CONCEPTUAL REVIEW

① CAR WASH ON NORTH COLLEGE - SOUTH OF EVER-OPEN CAFE
1420 N. COLLEGE

Conley
Larimer County
SH 287
1420 N. College PUD

ITEM: 48-87A 1420 NORTH COLLEGE PUD Final

CURB AND GUTTER Type 2
(6" Barrier - 2' Gutter) (Section II B)

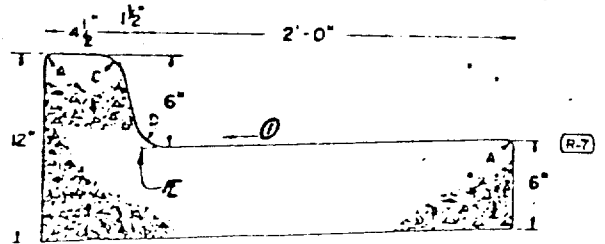
The enclosed sheet shows the standard curb and gutter which should be provided. In addition, we recommend that handicapped curb ramps be constructed where the sidewalk meets the driveway, as shown on the standards sheet.
